Project: 24.1095

**MCSC Lobby & General Improvements**

Written Addendum No.2

City of Kenora

JLS A100r1

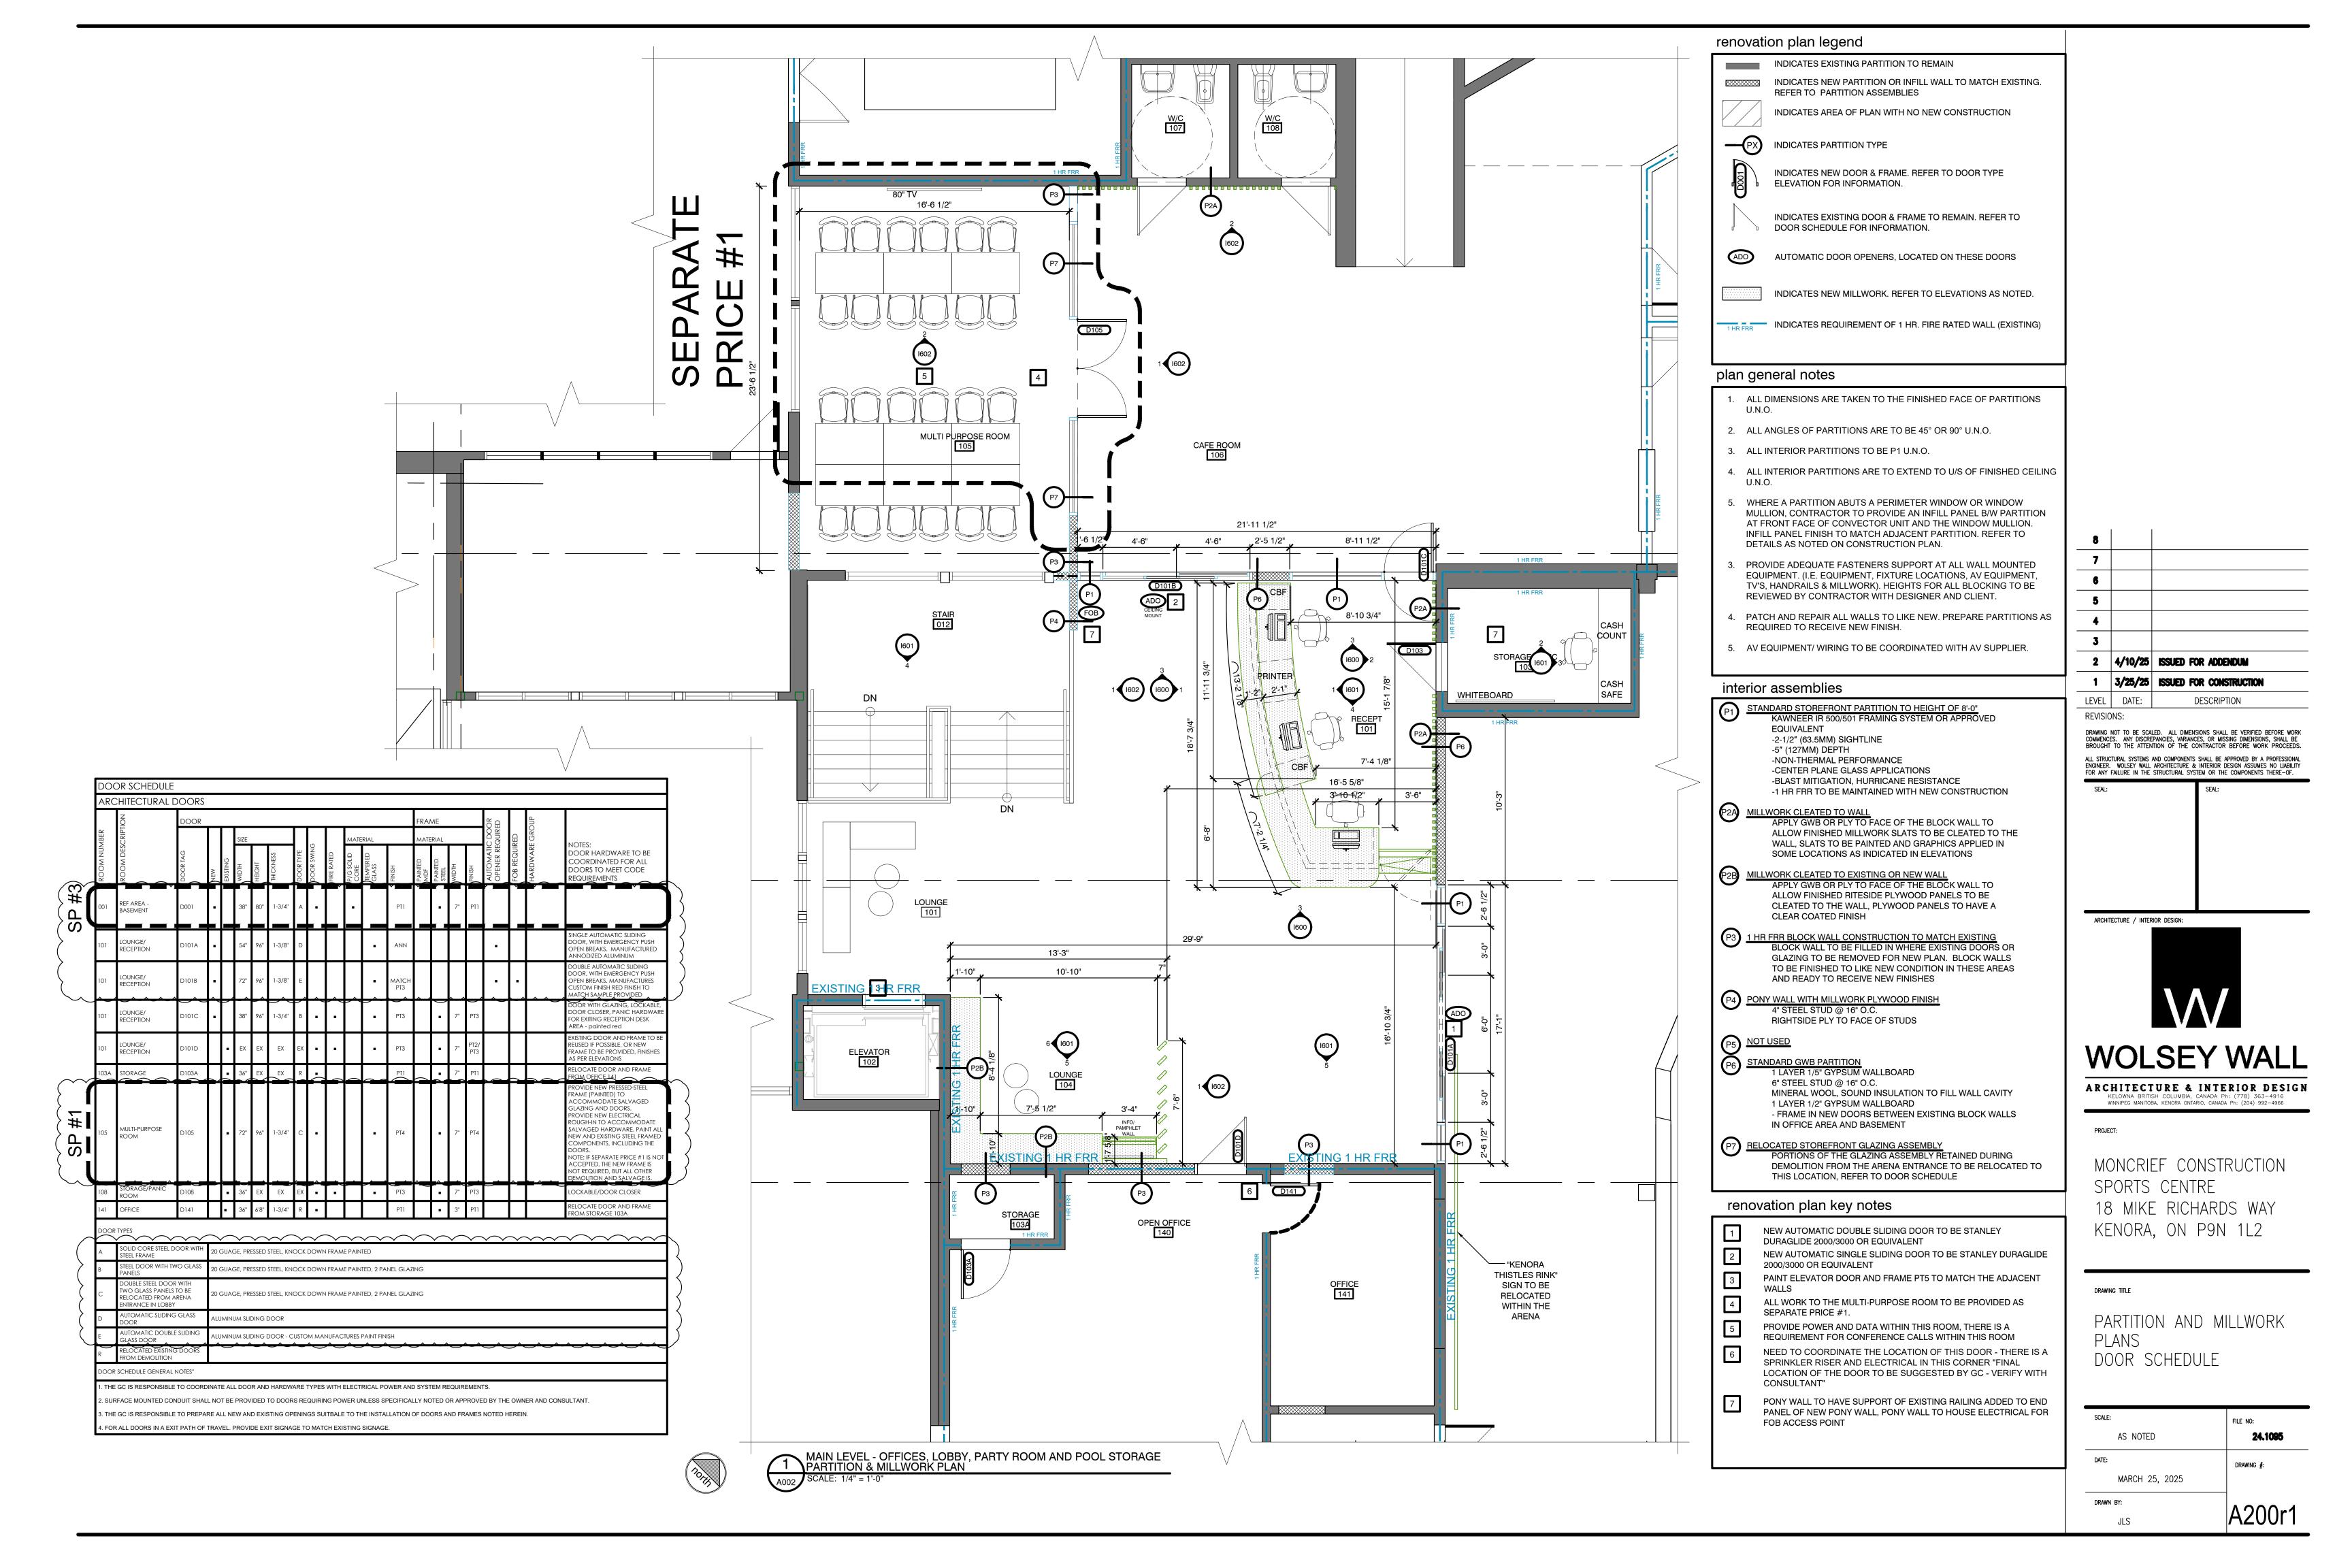
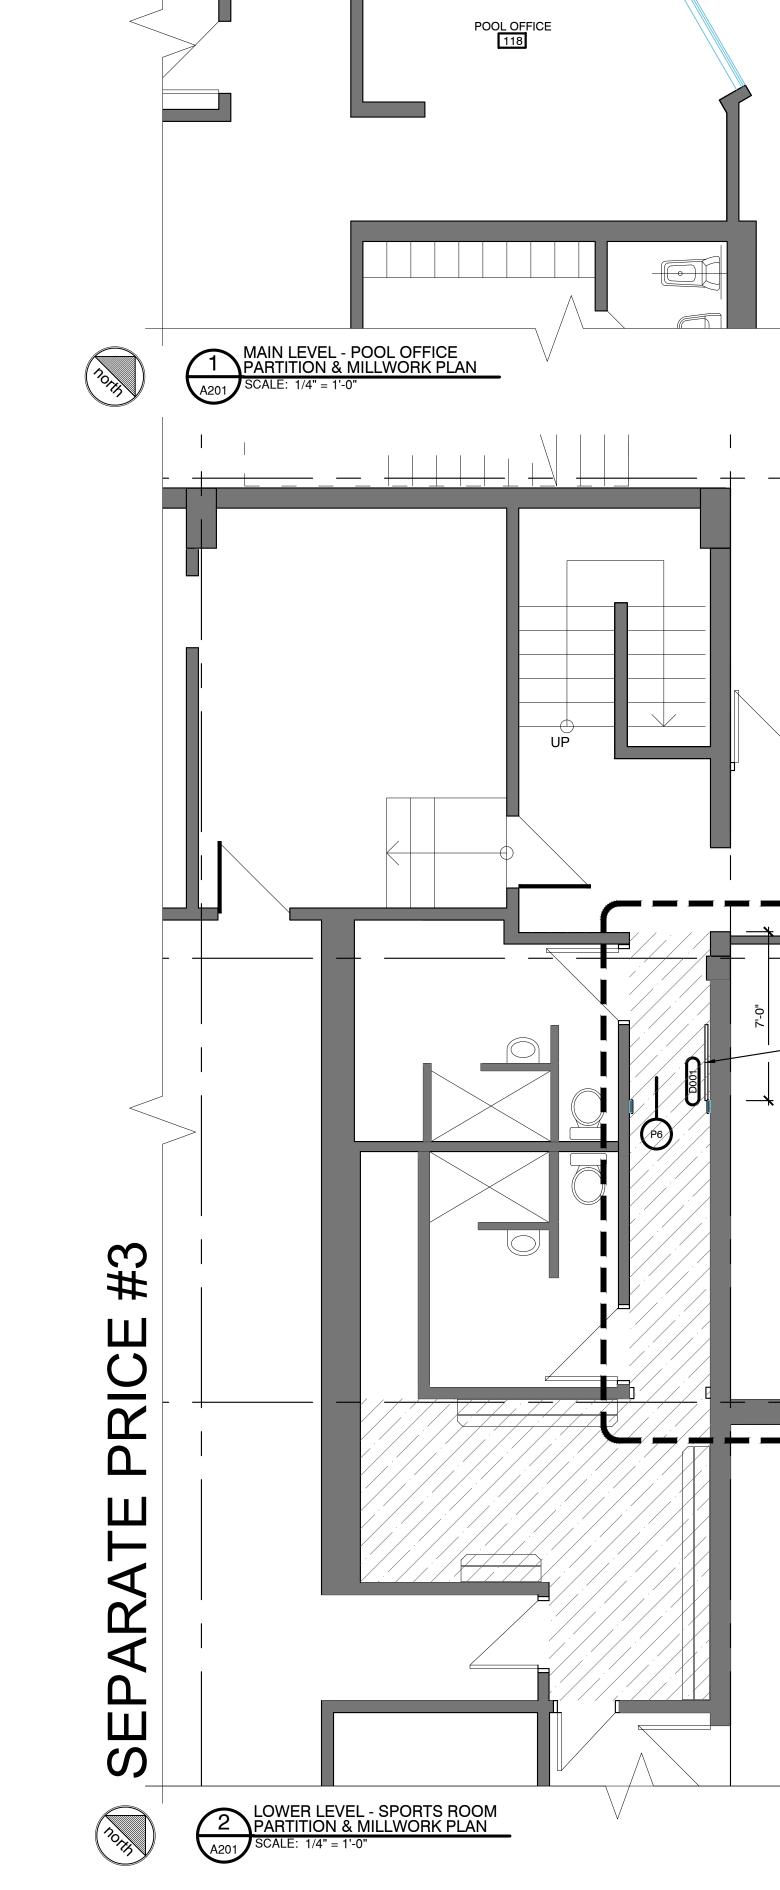
- Additional notes pertaining to the demolition, removal and salvage of the existing rink door and glazing steel framed assemblies, relative to Separate Price #1
- 2. Additional demolition notes to include the salvage of the existing "Kenora Thistles" signage.

AS NOTED 24.1095 DRAWING #: MARCH 25, 2025 A201r1

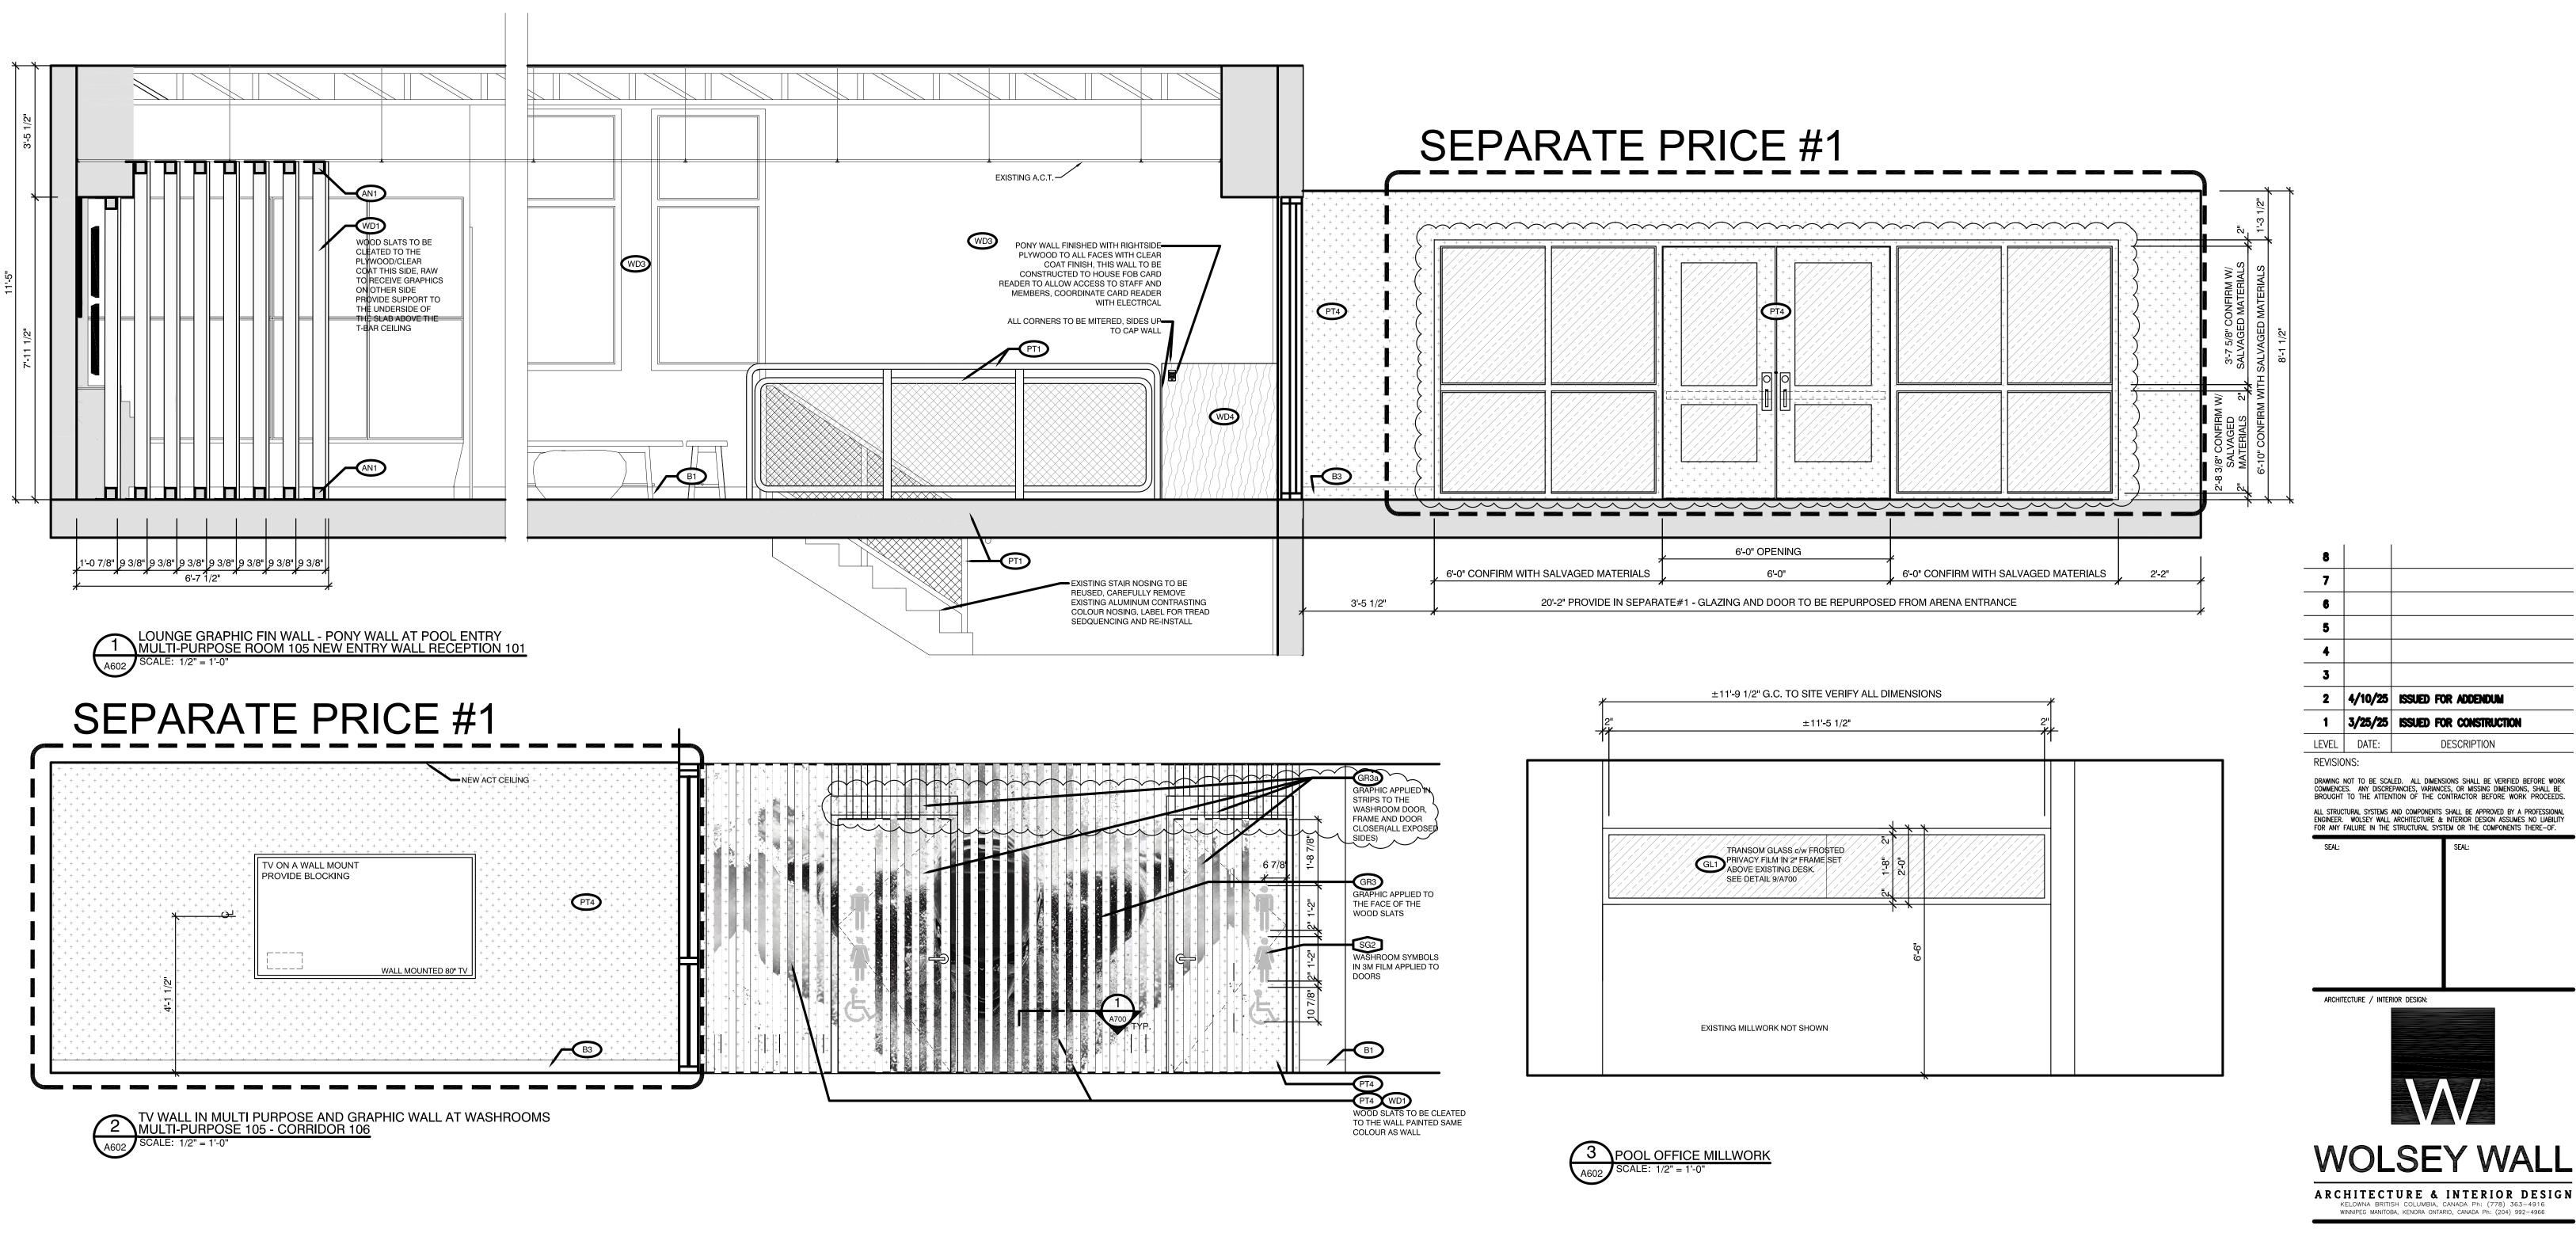
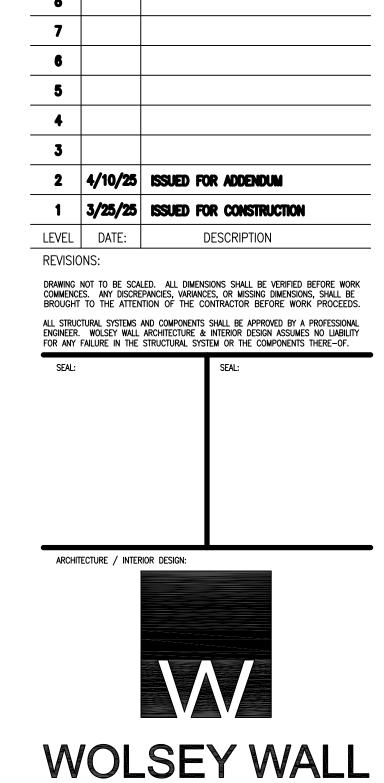
1. Additional notes, specifications and revisions to the Door Schedule
